**DWR PERRIS DAM
EMERGENCY RELEASE FACILITY**

**Addendum No. 2
SCH No. 2013091027**

**Prepared for
Department of Water Resources**

December 2022

Figure 3
Proposed Channel Underdrain Conceptual Design

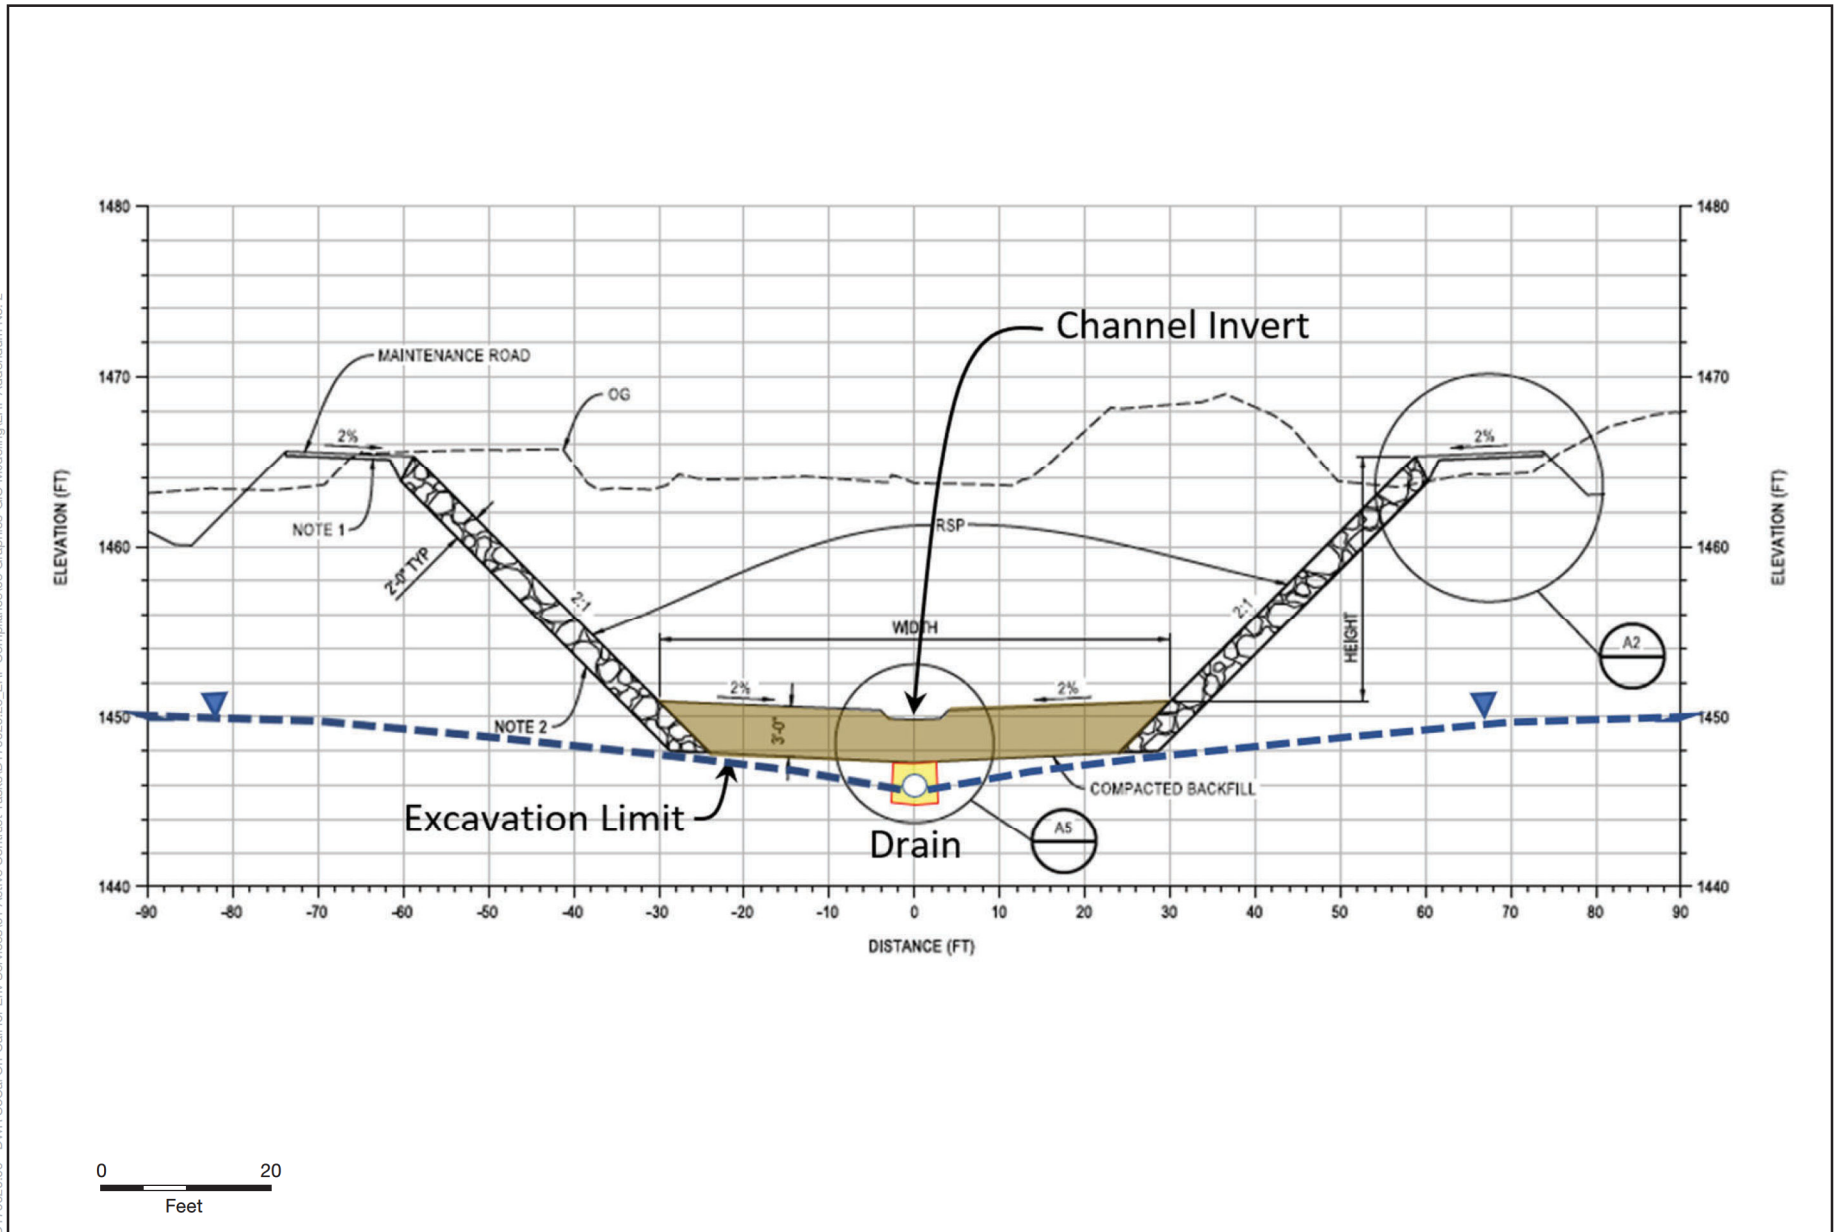
Since 2005, monitoring wells have been added along the channel alignment. Well data along the proposed channel alignment indicate there is potential for the depth to groundwater to periodically rise above the bottom of the proposed channel (channel invert) resulting in surface water within the channel. Therefore, the proposed modification includes installation of an

underdrain to be constructed under the centerline of the channel, along the entire channel length (Figure 2). This would constitute a minor design change that would not increase the footprint or capacity of the channel. The purpose of the underdrain would be to prevent groundwater from pooling within the new channel.

The channel underdrain would function by intercepting groundwater as it rises from below the channel bottom. It is not anticipated that groundwater would be collected over the entire length of the channel nor on a continuous basis; rather, groundwater is anticipated to rise high enough to be intercepted only immediately downstream of the two proposed drop structures and only during seasonal periods of high groundwater. The groundwater levels downstream of Perris Dam are typically the highest between April and June. The water collected in the channel underdrain would flow downstream to the west, towards the existing Perris Valley Channel.

The proposed underdrain pipe would be a slotted, 12-inch diameter PVC pipe. The underdrain pipe would be surrounded by crushed rock wrapped in filter fabric. The slotting, crushed rock, and filter fabric would allow groundwater to enter the channel underdrain in locations of high groundwater while simultaneously allowing collected water to flow out of the pipe in locations where the groundwater table is lower. The channel underdrain would be underground for the entire length of the channel except where it connects to the Perris Valley Channel (**Figure 3**). It is anticipated that the majority of collected groundwater would infiltrate back into the ground before it reaches the Perris Valley Channel. In the event that not all the water infiltrates back into the ground, the channel underdrain would terminate at a concrete wingwall in the Perris Valley Channel and would be protected by a flap gate. The flap gate would allow any excess water which has not infiltrated back into the ground to drain into the Perris Valley Channel and also prevent flows within the Perris Valley Channel from entering the channel underdrain. Cleanout locations would be added along the proposed channel to facilitate future maintenance of the channel underdrain.

Figure 4
Proposed Levee Modification with Wire Mesh

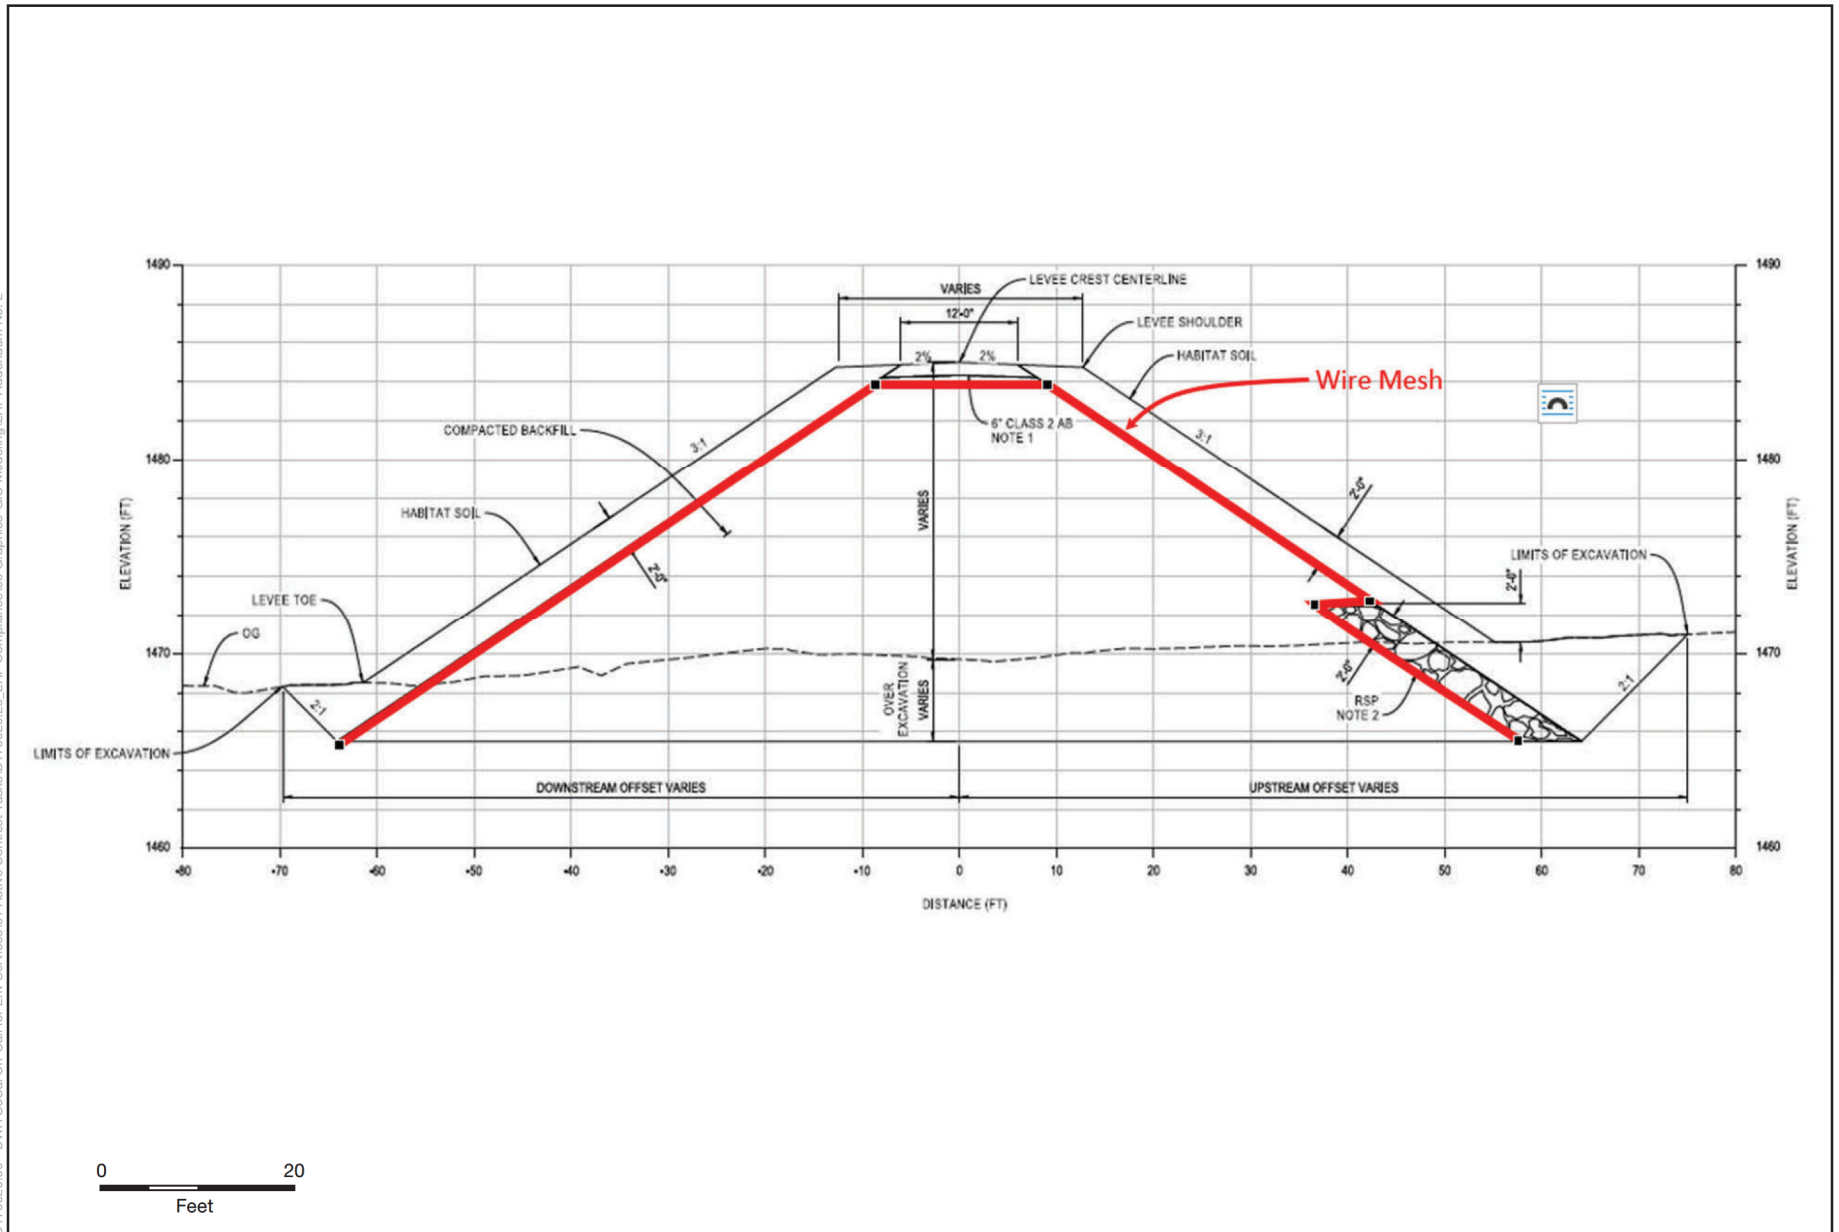
In order to minimize the need for future maintenance of the levee system, DWR would add a PVC-coated steel wire mesh between the habitat soil layer and the compacted fill portions of the levees that would act to protect the levee core's composition. The wire mesh would reduce the need for levee maintenance and repairs. Without the wire mesh, the compacted soil core could be subject to erosion from burrows and roots in the upper layer that could result in levee failure during a flood event. The wire mesh would be added along both sides of the levees and would cover the entire length of both levees. The wire mesh has 0.5-inch by 0.5-inch openings and comes in large rolls of 6 feet by 100 feet. The top 2 feet of habitat soil along the levees would remain the same, loosely compacted and revegetated soil to allow for small mammals to burrow and utilize the levees as habitat (**Figure 4**).

Approximately 1,580 rolls of coated wire mesh would be required to cover the levee embankment. The wire mesh would be installed using a spreader bar assembly attached to a front-end loader, backhoe or excavator bucket. The wire mesh would be secured by sandbags initially. Rolls would be overlapped a minimum of eight inches and connected by steel C-ring staples. Twelve-inch-long pins would be used to secure the wire mesh to the embankment. Construction of the wire mesh would require six to eight construction workers daily. Approximately 13 to 16 truck trips would be required to import materials to the proposed Project site for the levee wire mesh installation. Once installed, the wire mesh would be covered with two feet of topsoil to support revegetation and allow for small mammal re-occupation.
